HARDY ASSOCIATES (1978) LTD.

November 30, 1979

Re: Grum Deposit

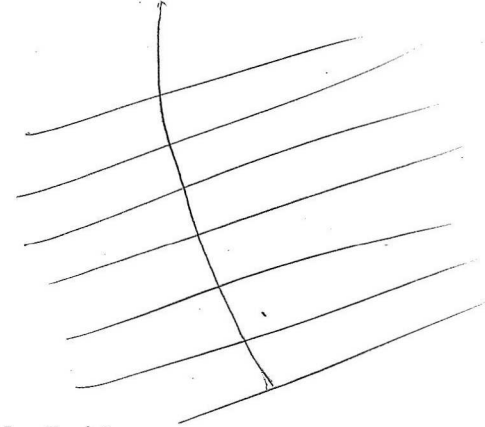
*borehole deflection?
foliations 4's*

3.2.1 Overall Wall

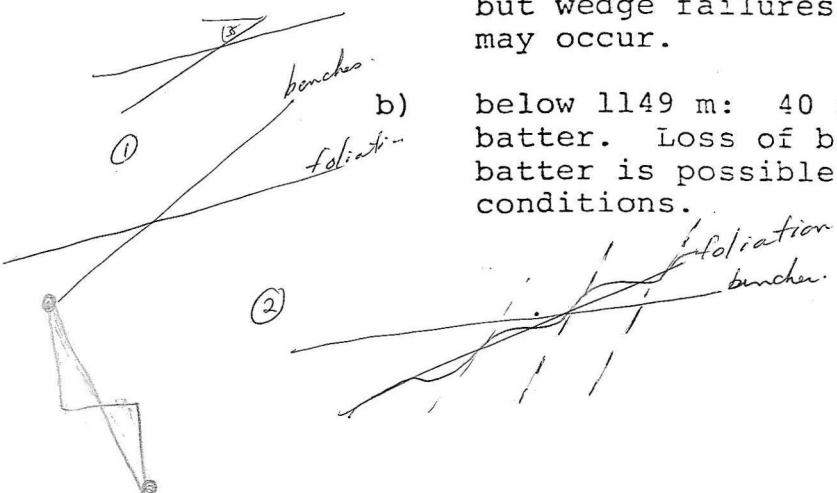
- a) above 1149 m: 35 to 40° is kinematically acceptable. *- more work required*
- * b) below 1149 m: 29 to 32° (corresponding to true foliation dips of 35 to 40°).

*varies from
mean dip of 6°
assumed.*
